For Official Use Only 請勿填寫此欄	Application No. 申請編號	A/YL-TT/633
	Date Received 收到日期	11 JAN 2024

**Proposed Temporary Shop & Services for a Period of 3 Years
at
Lots 4073 (Part), 4074 (Part), 4075 (Part), 4076 RP (Part) & 4087 (Part)
in D.D. 116, Tai Kei Leng, Yuen Long, New Territories**

Proposed Temporary Shop & Services for a Period of 3 Years at Lots 4073 (Part), 4074 (Part), 4075 (Part), 4076 RP (Part) & 4087 (Part) in D.D. 116, Tai Kei Leng, Yuen Long, New Territories

Figure 4

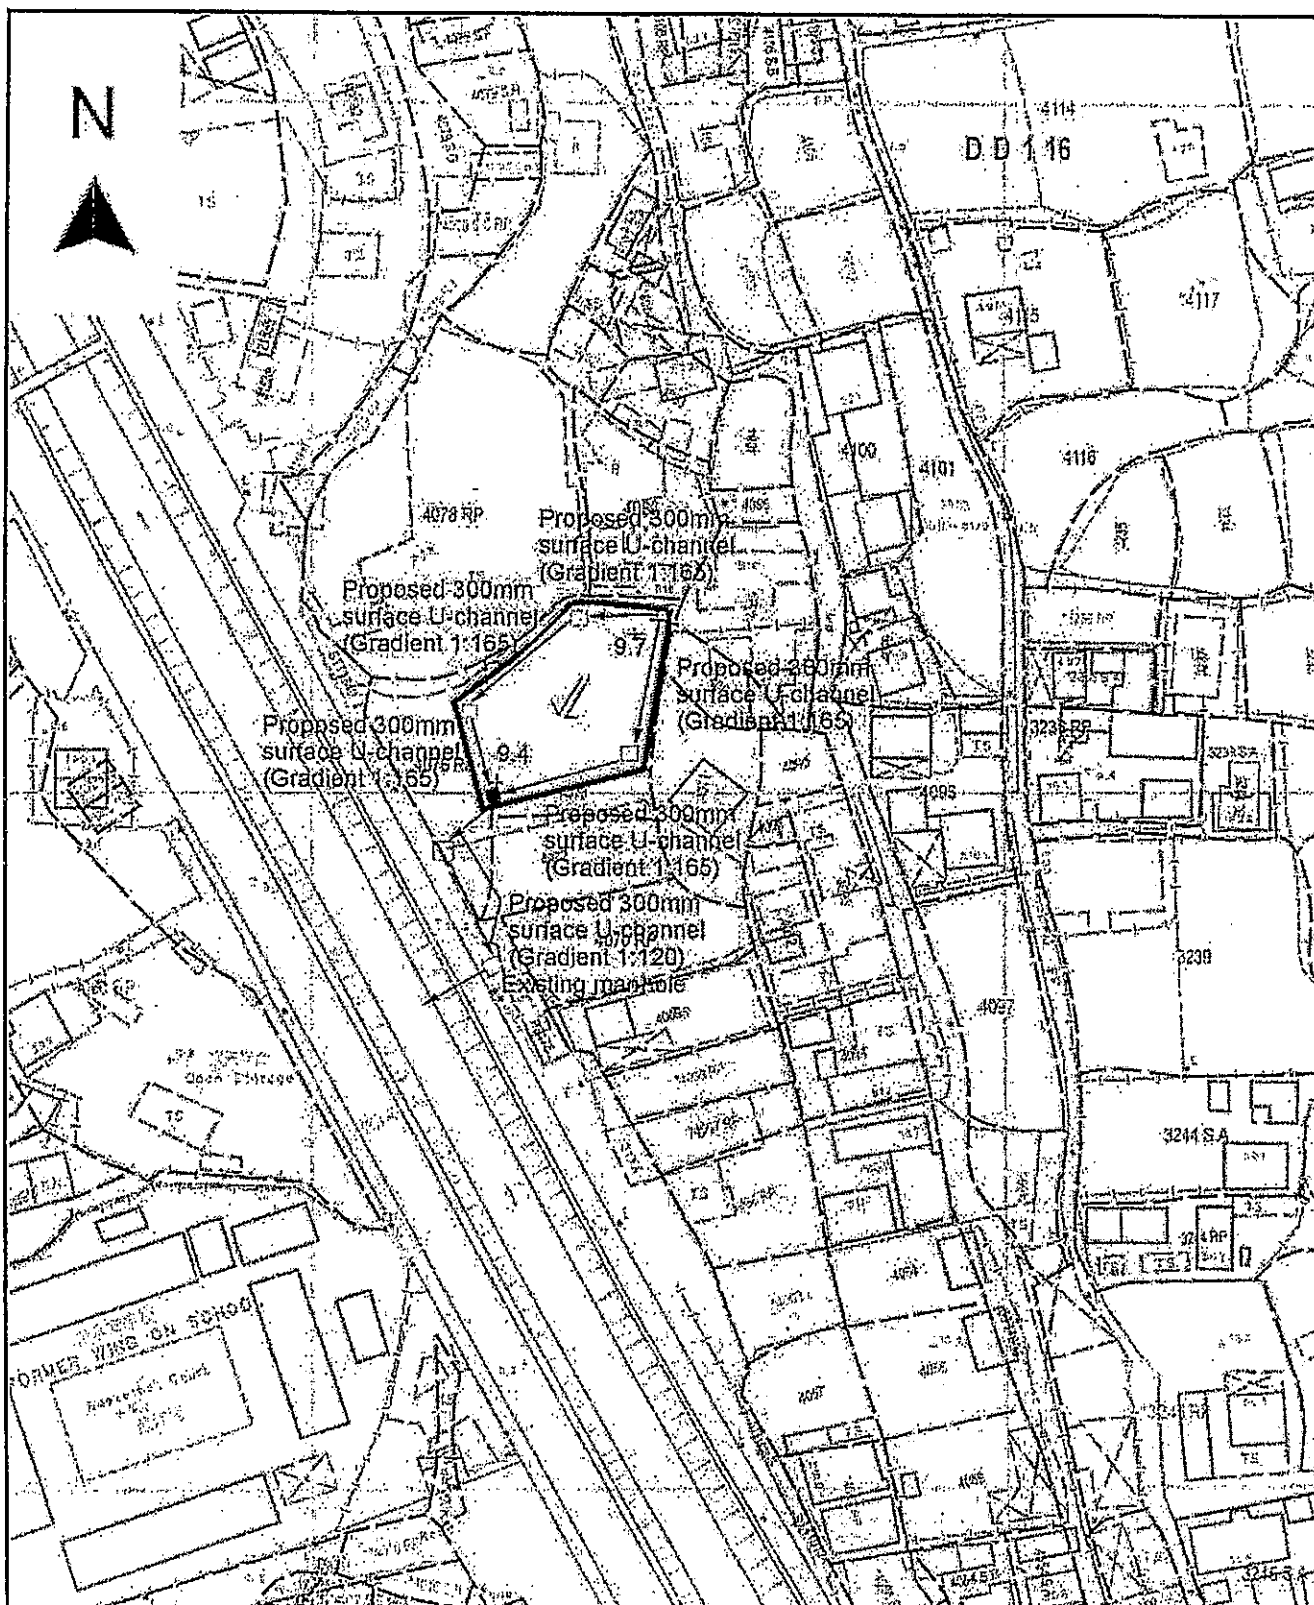
- (e) to note the comments of the Chief Engineer/Mainland North, Drainage Services Department (CE/MN of DSD) that:
- (i) the submitted drainage plan is illegible, the applicants shall provide a clear version for submission;

- (ii) the size of drainage facility between the existing manholes at Tai Shu Ha Road East should

be indicated. The applicants should check and ensure the hydraulic capacity of the existing drainage facilities would not be adversely affected by the proposed use;

- (iii) the existing manhole where the applicants proposed to discharge the stormwater from the Site was not maintained by DSD. The applicants should identify the owner of the existing drainage facilities and obtain consent from the owner prior to the commencement of the proposed works. In the case that it is not a local village drains, District Officer (Yuen Long) should be consulted;

- (iv) further to (iii) above, since there is no record of the said discharge path, please provide site photos to demonstrate the presence and existing condition of the discharge path should be provided;

- (v) the connection details of the proposed drainage facilities from the terminal manhole to the existing manhole should be provided for review and comments;

- (vi) the gradients and sizes of the proposed U-channels should be shown on the drainage plan;
 - (vii) cross sections showing the existing and proposed ground levels of the Site with respect to the adjacent areas should be given;

- (viii) the cover levels and invert levels of the proposed U-channels, catchpits/sand traps should be shown on the drainage plan;
 - (ix) if any walls or hoarding are to be erected or laid along the site boundary, adequate opening should be provided to intercept the existing overland flow passing through the Site and its details should be provided for comments;

Figure 3

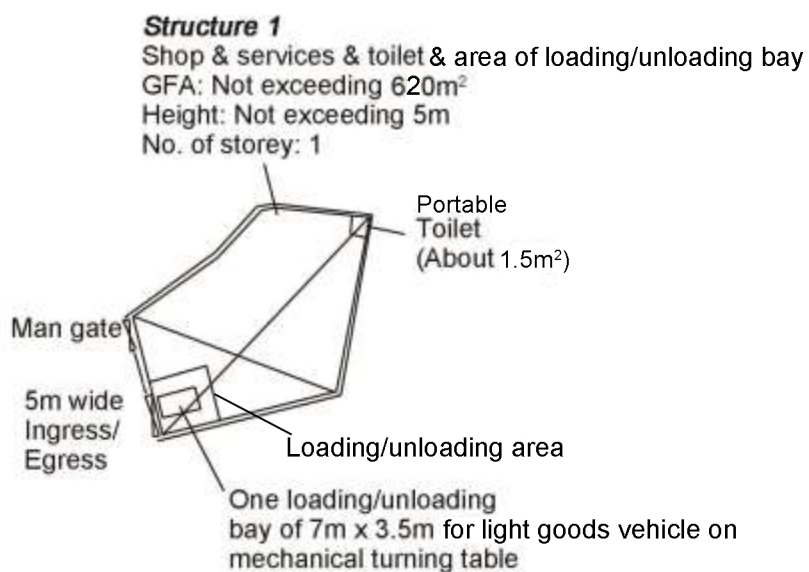
EPD comments	Response
a) whether the toilet indicated in the layout plan is a portable toilet, if affirmative, whether licensed collectors will be recruited to collect and dispose the sewage and waste from the portable toilet;	A portable toilet is shown in the attached layout plan. Licensed collectors will be recruited to collect and dispose the sewage and waste from the portable toilet.

b) whether the septic tank and soakaway system will be provided and if affirmative, whether the septic tank and soakaway system will be designed and constructed according to the requirements of EPD's ProPECC PN 1/23, including requirements for minimum clearance distance, percolation test and certification by Authorized Person;	Portable toilet will be provided within Structure 1.
